**IN THE DRAWINGS:**

FIG. 3

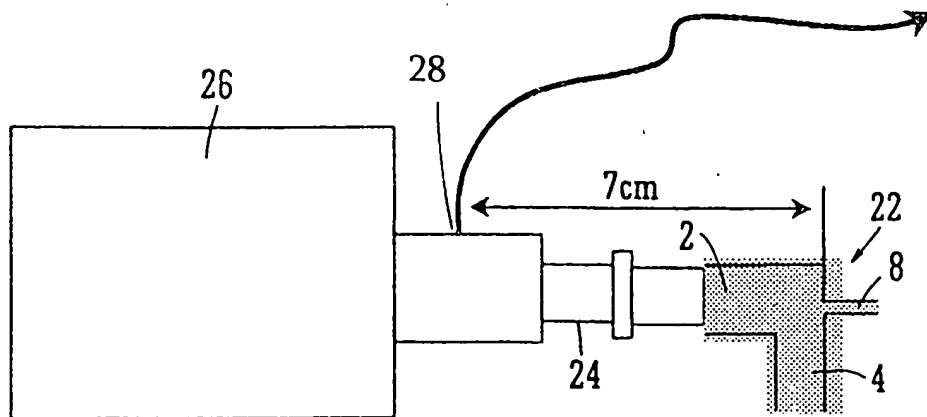
Please consider the proposed modification to Figure 3 which adds reference numeral 28 to the pressure feed which is depicted as a curvilinear line ending in an arrow and which extends from tube 24 at a point 7 cm from the end of the gas inlet channel 8. Included with this amendment is a clean copy of the affected drawing sheet incorporating the above-described change to Figure 3.
